ADA Curb Ramp New Construction Inspection Form (Parallel)

NW 307th

23885.56

Eggiman Ct

PARALLEL RAMP (PL)

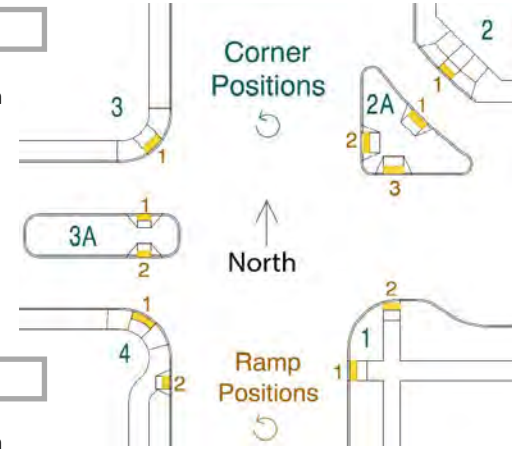
2.7 \leq 2.0% ☐ > 2.0% ☒

8.5 \leq 8.3% ☐ > 8.3% ☒

2.7 \leq 2.0% ☐ > 2.0% ☒

Poor craftsmanship, RR2, IITD
